# YESLER TERRACE BLOCK 3 | 120 BROADWAY

MUP# 3020159  
DESIGN RECOMMENDATION PACKET  
SEPTEMBER 28, 2016

# EDG REPORT GUIDANCE AND RESPONSE

**CS1-A & CS1-B: Bird's eye view showing the residential open spaces oriented towards the south.**

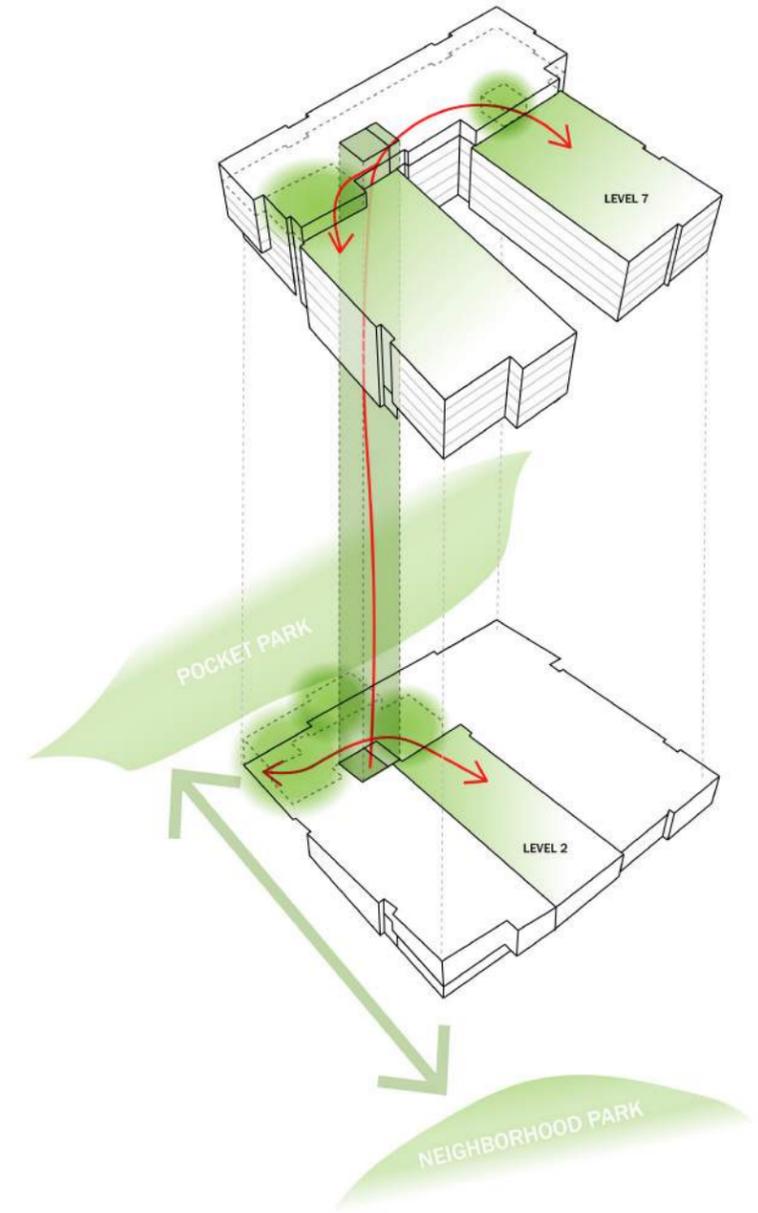
CS1-A & CS1-B. The Board observed that the preferred massing appeared to provide a good overall response to solar access for open space and the adjacent pocket park. The Board directed the applicant to design the residential open spaces with consideration of shading from buildings and trees.

In terms of solar response, the west leg of the U-shaped massing angles out to maximize light into the south-facing courtyard. Roof overhangs along the north facade are limited to a maximum of 2' to minimize shading to the park. Residential open space located on two roof decks take advantage of the solar exposure and views to Mt. Rainier and Puget Sound. The south facing courtyard features a prow element to extend the residential outdoor space further towards the street and provides a visual connection to Yesler Way.

**PL1-A & PL1-B: The main residential lobby entry opens up off the pocket park and ground level residential units have balconies that overlook the pocket park.**

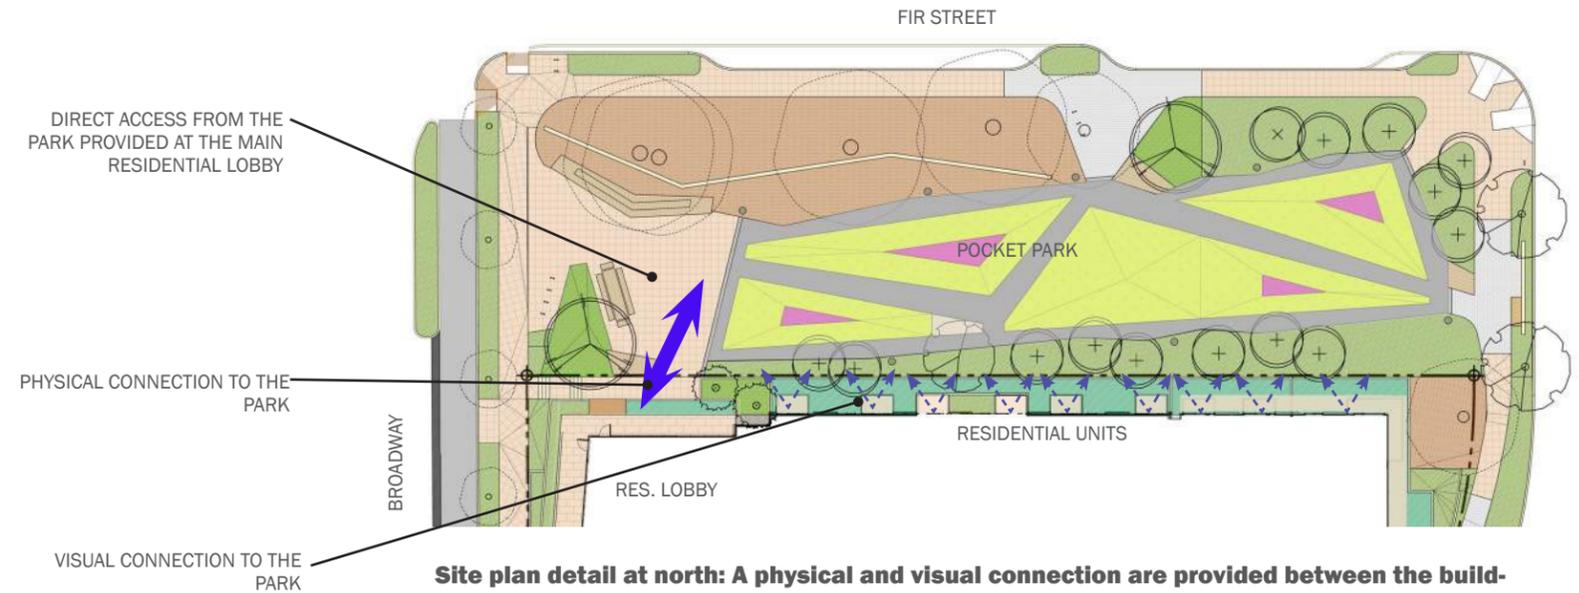
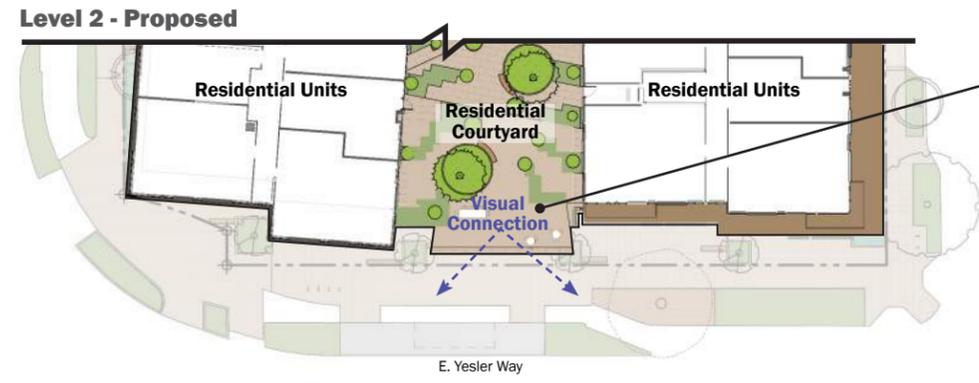
The Board recommended more porosity at the north edge. If possible, provide direct access to the park, while still designing the transition between building and park to provide a visual separation between the public park and the private property. The Board recommended that the upper level courtyard be visually and physically connected to the Yesler Way street level.

At the north edge, a direct connection to the pocket park is made at the main lobby entry. The floating deck at the main lobby entry connects to the park with a steel bridge. East of the lobby, residential units at grade will have decks and will provide visual surveillance over the park.

Instead, a visual connection between the courtyard and the Yesler R.O.W. is achieved by an elevated deck that extends above the sidewalk, creating a space for residents to visually engage with the Yesler R.O.W. below. There will be planting material flanking portions of the prow's edges that will be visible from E Yesler Way.

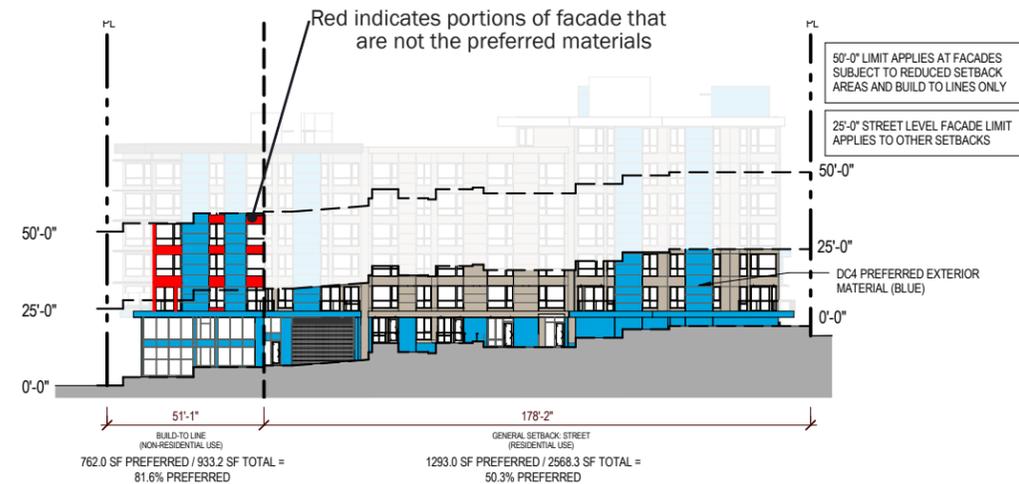
DC4-A *Yesler Terrace Supplemental Guidance:* Use materials that have a durability that is appropriate for an urban application. Masonry, integral color cement plaster, metal, and concrete are preferred primary facade materials. Where wood and heavy timber are exposed to weather, provide appropriate protection to increase their durability.

All the street-level facades exceed the 50% preferred materials guidance. See Diagrams A through D below; DC4 preferred materials in blue.

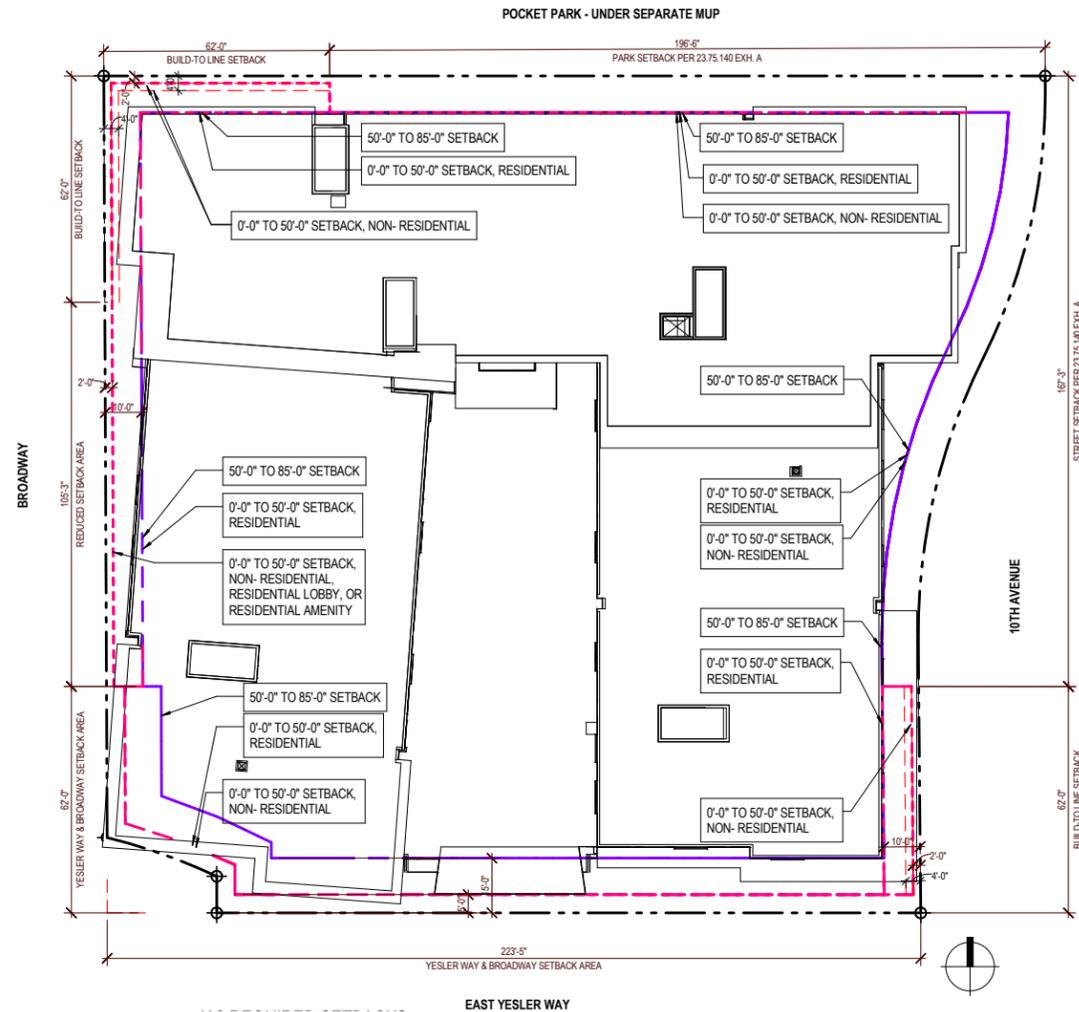
At the EDG meeting, the Board indicated preliminary support for the departure, based on the proposed massing response to the unusual lot configuration and the strong architectural expression at Yesler Way.

A. The encroachment into the setback at the southwest corner is the result of providing a strong corner design at the intersection of Yesler and Broadway, an important node within Yesler Terrace (CS1-C, CS3, DC2-A). The sunshades provide additional scale, texture, and depth to the façade (DC2). The roof emphasizes the corner massing articulation and breaks down the overall vertical scale by clearly defining the "top" of the element (CS2, DC2).

B. The deck above the garage (and its supporting wall) is an extension of the elevated horizontal plane, which is an organizing element within the façade composition (DC2-B-1). The deck accentuates the corner expression at 10th & Yesler (CS2). Additionally, the deck is a secondary element which serves to add depth and scale to the façade (DC2-C).

C. The overhanging roofs serve as elevated horizontal planes which help define a "top, middle, and base" (CS2). The overhangs also further articulate the massing between the corner and middle volumes (DC2).
